# National Committee on Uniform Traffic Control Devices

**RW Item No. 2**

**TECHNICAL COMMITTEE: Regulatory/Warning Signs Technical Committee**

**TOPIC: Warning Signs, NEW Panel with Starburst (SSW-5b)**

Figure 2C-14 (NPA) - Eliminate the “starburst” from the NEW plaque

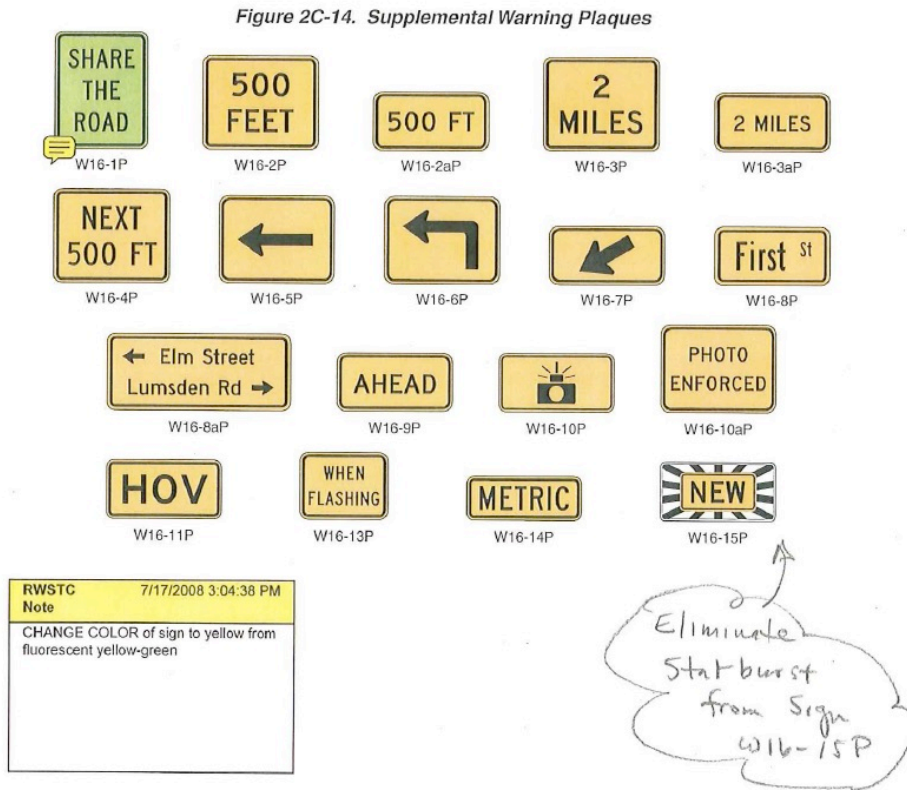
The NCUTCD Council approved changes to Section 2A.15 *Enhanced Conspicuity for Signs*, Section 2C.67 *NEW Plaque (W16-15P)* and Figure in January and June 2008. The panel shown in Figure 2C-14 shows the legend surround by a "starburst" for emphasis. While Section 2A.15 includes a number of forms of emphasis, it does not include the use of the "starburst". For consistency, eliminate the "starburst" from Figure 2C-14 and retain the NEW plaque without the "starburst".

The "starburst" form of emphasis is used in Canada. It is not in common use in the United States. The RWSTC is unaware of any research having been done on the effectiveness of the "starburst". Members of the RWSTC that have seen it in use in Canada and do not believe that adds effective emphasis.
